ORCHARD PARK SUBDIVISION

Engineering Comments: FINAL PLAT COMMENTS (should be addressed prior to submitting the FINAL PLAT for review and/or signature by the City Engineer):

APPLICATION NUMBER 3 DATE October 20, 2022

DETAIL SITE PLAN

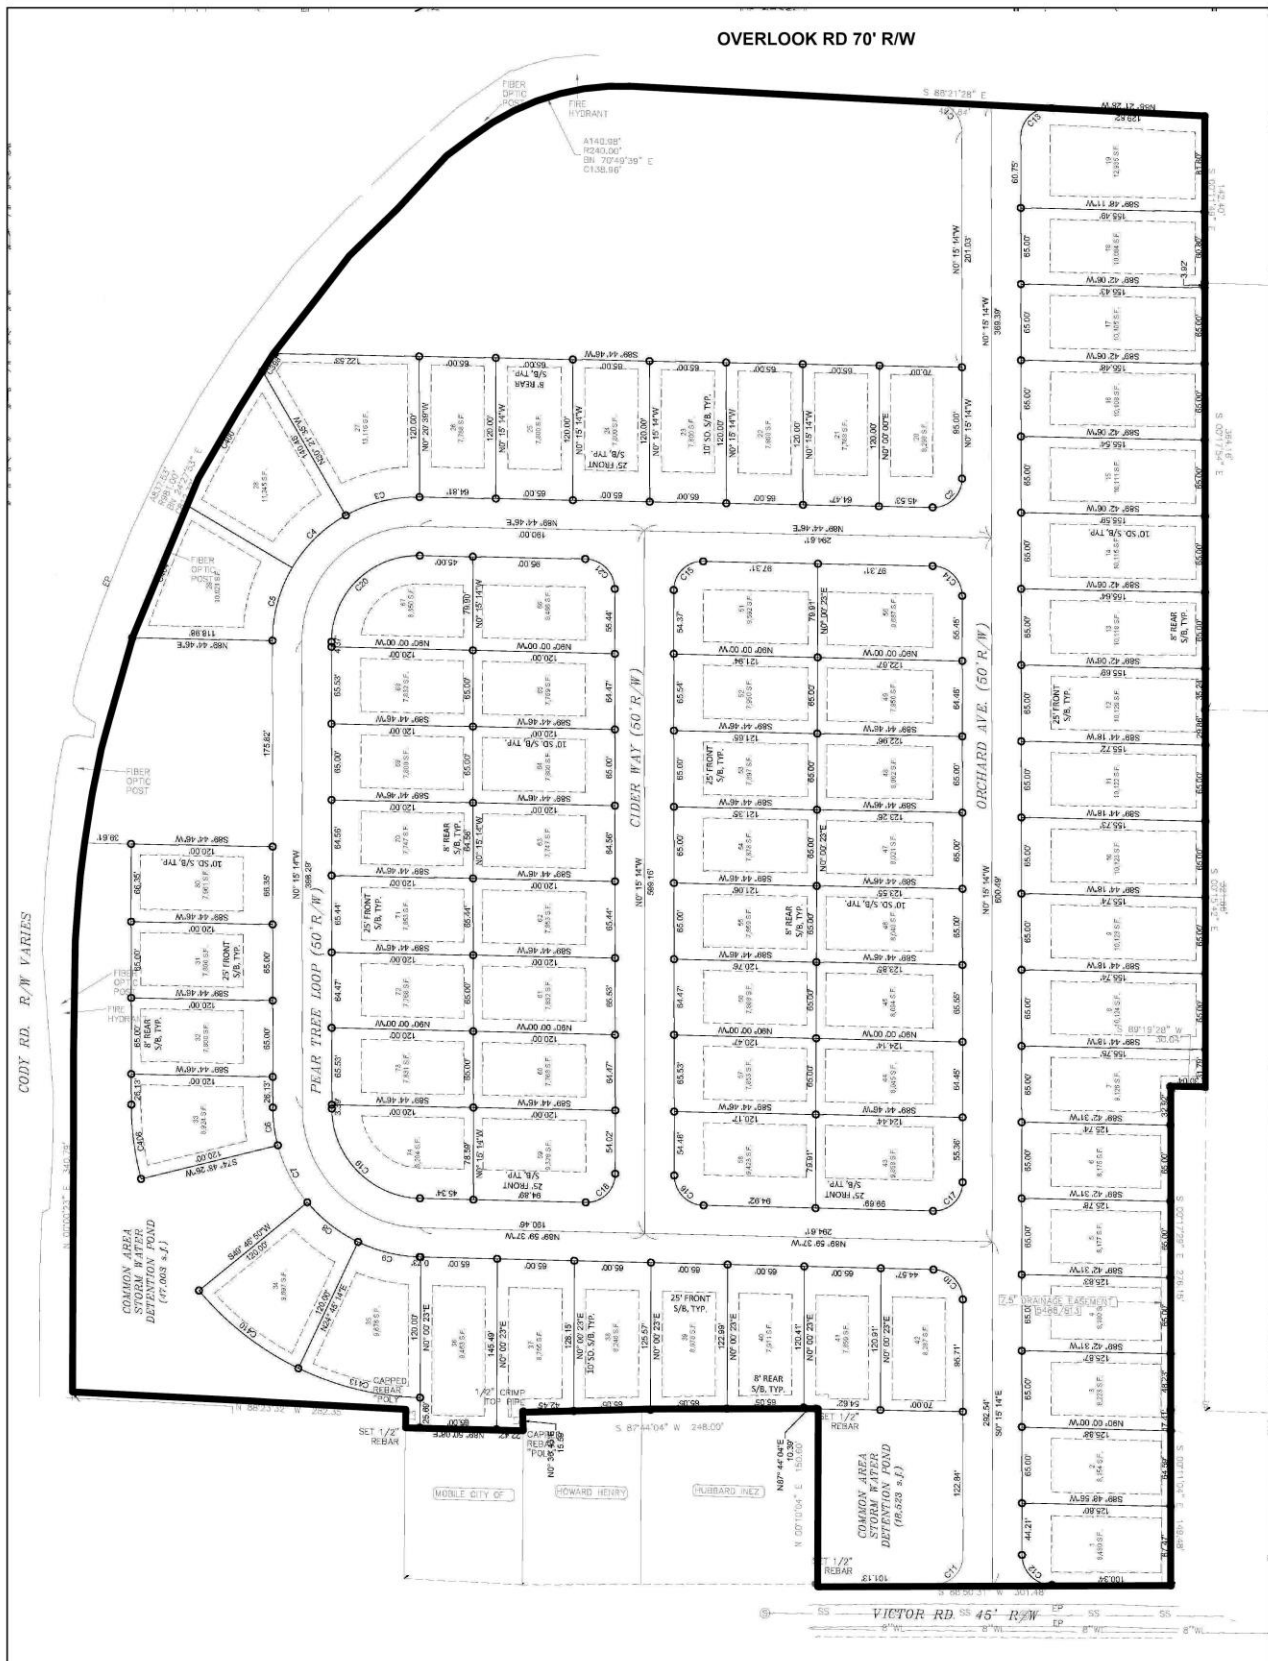
The preliminary plat indicates that access to the subdivision will be via both Overlook Road and Victor Road. Proposed streets are labeled to have compliant 50-foot rights-of-way, and these labels should be retained on the Final Plat, if approved. No information on street corner lot curve radii is provided. Therefore, the plat should be revised to label all street corner lots with at least a 25-foot corner radius.

The proposed lot sizes are provided only in acres, but not in square feet. If approved, the plat should be revised to label the lots with their sizes in both square feet and acres, after any required dedication, or a table should be furnished on the Final Plat providing the same information, after any required dedication.

All lots are indicated to have a compliant and standard 25-foot minimum building setback from the street frontages, except those lots with frontages along Victor Road, Overlook Road and Cody Road North. The plat should be revised to indicate a 25-foot minimum building setback line along these street frontages for Lots 1, 19, 27, 28 and 29, as measured from any required street frontage dedication. A "Typical Lot Building Setback Layout" provided on the plat implies that all lots would have the same utilities easement and setback configuration. However, most corner lots differ from these setbacks. This layout should be revised to indicate which lots would be subject to this standard layout and which lots would differ. As easements are indicated, the note on the preliminary plat stating that no structures may be placed or constructed within any easement without the permission of the easement holder should be retained on the

Final Plat, if approved. The Typical Lot Building Setback Layout should be revised to also illustrate compliant rear and side yard setbacks.

The preliminary plat labels two (2) areas as Common Areas, with their sizes in square feet provided. The size labels should be revised to also include the area in both square feet and acres for each Common Area. There is a note on the preliminary plat stating that all proposed detention facilities, common areas and wetlands shall be the responsibility of the property owner(s) and not the responsibility of the City of Mobile. This note should be revised on the Final Plat to simply state that the maintenance of all Common Areas is the responsibility of the property owners.

Additionally, there is a note on Sheet 2 which states that the intended use is commercial development. As the site is zoned residentially and the lots are residential in dimension, this note should be deleted on the Final Plat.

- 1) finalization of OBC Subdivision prior to signing the Final Plat;
- 2) revision of the plat to label Overlook Road, Cody Road North and Victor Road with their current rights-of-way after any dedication required with OBC Subdivision;

- 3) revision of the plat to label the sizes of Lot 1 and the Common Area along Victor Road, and Lots 27, 28 and 29, and the Common Area along Cody Road North after any dedication required with OBC Subdivision;

- 4) retention of the right-of-way width labels for all interior streets on the Final Plat;
- 5) revision of the plat to label all street corner lots with at least a 25-foot corner radius, or the furnishing of a table on the Final Plat providing the same information;

- 6) revision of the plat to label each lot and Common Area with its size in both square feet and acres, after any required dedication, or the furnishing of a table on the Final Plat providing the same information;

- 7) revision of the plat to indicate 25-foot minimum building setback line along Victor Road for Lot 1, after any required dedication;
- 8) revision of the plat to indicate a 25-foot minimum building setback line along Overlook Road for Lot 19;

- 9) revision of the plat to indicate a 25-foot minimum building setback line along Cody Road North for Lots 27, 28 and 29;

- 10) revision of the Typical Lot Building Setback Layout to indicate which lots would be subject to this standard layout and which lots would differ, and to include compliant front, side and rear yard setbacks;

- 12) revision of the note concerning the maintenance of the Common Areas to simply state on the Final Plat that the maintenance of all Common Areas is the responsibility of the property owners;

- 14) removal of the note stating that the intended use is commercial development;
- 15) compliance with the Engineering comments: *(FINAL PLAT COMMENTS (should be addressed prior to submitting the FINAL PLAT for review and/or signature by the City Engineer): A. Provide all of the required information on the SUBDIVISION PLAT (i.e. signature blocks, signatures, certification statements, written legal description, required notes, legend, scale, bearings and distances) that is required by the current Alabama State Board of Licensure for Professional Engineers and Land Surveyors. B. Provide reference, on the map and the description, to a monumented corner. C. Provide and label the monument set or found at each subdivision corner. D. Provide a Vicinity Map. E. Provide a North Arrow on Sheet 1 of 2. F. Provide a legend. G. Provide curve data for the various labeled curves. H. Provide the curve numbers and curve data for the proposed rights-of-way. I. Mark each proposed ROW as PUBLIC or PRIVATE. J. Is the USPS requiring a mail kiosk? Show and label the proposed kiosk on private property. K. Street names are subject to approval through the Engineering Dept. L. Clarify the existing ROW on Victor Rd. Show and label the distance to centerline of roadway. M. Give a unique label to each of the separate Common Areas (i.e. No. 1, No. 2). N Label LOT 1 and LOT 3 of OBC Subdivision and include the recording information. O. Show and label each and every Right-Of-Way and easement. P Label the adjoining property Owners. Q. Revise NOTE #9 (unnumbered) to read – “All existing and proposed detention facilities, common areas, and wetlands shall be the responsibility of the Property Owner(s), and not the responsibility of the City of Mobile.” R. Provide a written legal description and matching bearing and distance labels for the proposed subdivision boundary. S. Revise the plat to label each lot with its size in acres also, or the furnishing of a table on the Plat providing the same information. T. Revise the signature block from “MOBILE CITY ENGINEERING” to “CITY ENGINEER”. U. Provide the Surveyor’s Certificate. V. The proposed streets are considered PRIVATE until the roadways and dedicated ROW are accepted by the City. W. Email a pdf copy of the FINAL SUBDIVISION PLAT and LETTER OF DECISION to the Permitting Engineering Dept. for review at land.disturbance@cityofmobile.org prior to obtaining any signatures. No signatures are required on the drawing.);*
